LIPSCOMB SUBDIVISION

APPLICATION NUMBER 5 DATE June 15, 2017

REQUEST Subdivision

DETAIL SITE PLAN

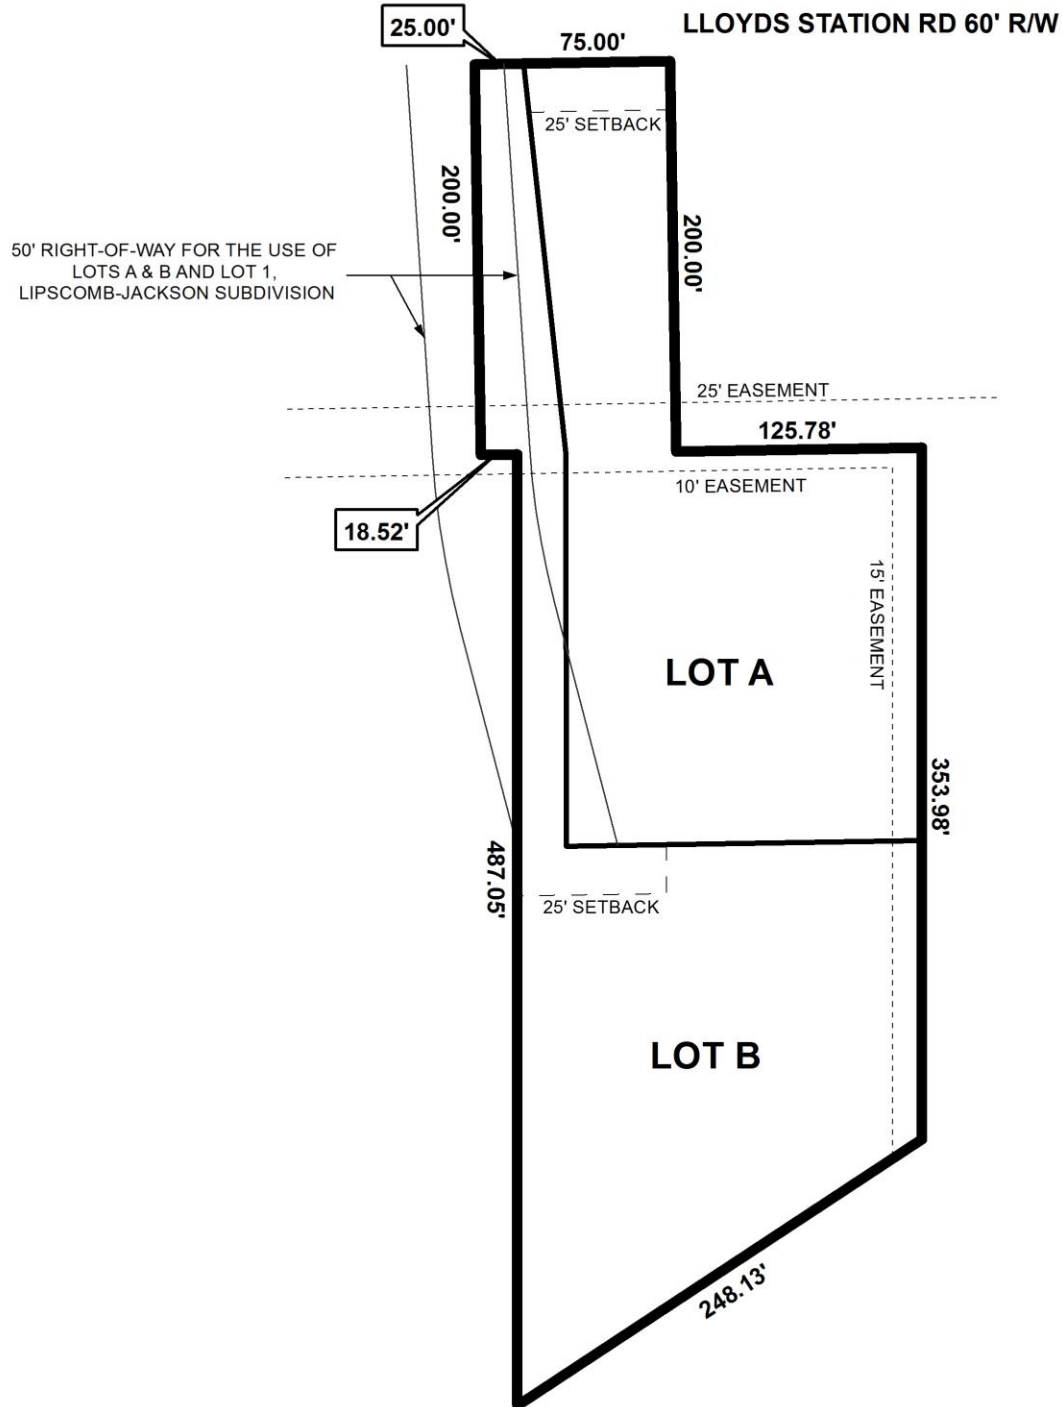
Engineering Comments: According to NOTE #12 of the Lipscomb-Jackson Subdivision (MB130, PG 31) Lot 2 is not allowed to be subdivided. FINAL PLAT COMMENTS (should be addressed prior to submitting the FINAL PLAT for review and/or signature by the City Engineer):

- B. National Wetlands Inventory (NWI) mapping, as shown on City of Mobile GIS information, indicates that there is potential for wetlands within the property or properties shown on this plat. Show and label the delineated wetlands, or provide a note that the wetlands shown on this plat are scaled from the NWI data and have not been delineated.

- C. Show and label all flood zones.
- D. Show and label the MFFE (Minimum Finished Floor Elevation) on each lot that contains an AE, V, or X (shaded) flood zone designation.

- E. Add a note clarifying the dashed lines that indicate an existing 50' ROW. Is this a Private ROW, or used as an access easement for LOTS 1 and 2 of Lipscomb-Jackson Subdivision (MB130, PG 31)?

- F. Provide and label the monument set or found at each subdivision corner.
- G. Add a signature block for the Owner, Notary Public, Planning Commission, Traffic Engineer, and City Engineer.

The 25’ minimum building setback line is depicted on Lot A and on a portion of Lot B, where the “pole” meets the “flag”.

The lot sizes in both square feet and acres are depicted on the preliminary plat and should be retained on the Final Plat, if approved. The proposed lots are unusually shaped, include a flag-lot and flag-lot characteristics, and appear to exceed the recommended width to depth ratio of the Subdivision Regulations. A waiver of Sections V.D.1. and V.D.3. of the Subdivision Regulations would be required if the Planning Commission were to approve the request.

Due to the limited frontage, if approved, a note should be placed on the Final Plat stating future subdivision of either lot should be prohibited until such time as additional frontage on a public or private street is provided.

It should also be noted that there appears to be several existing drainage and utility easements on the site. If approved, a note should be placed on the Final Plat stating that no permanent structures shall be constructed in any easements.

The proposed lots front Lloyd Station Road, a minor street which does not have curb or gutter. Since the proposed subdivision is a portion of a previously approved subdivision, no dedication will be required. As a means of access management, if approved, a note should be placed on the Final Plat stating that both lots are limited to one curb-cut each, with the size, design and location to be approved by Traffic Engineering and comply with AASHTO standards.
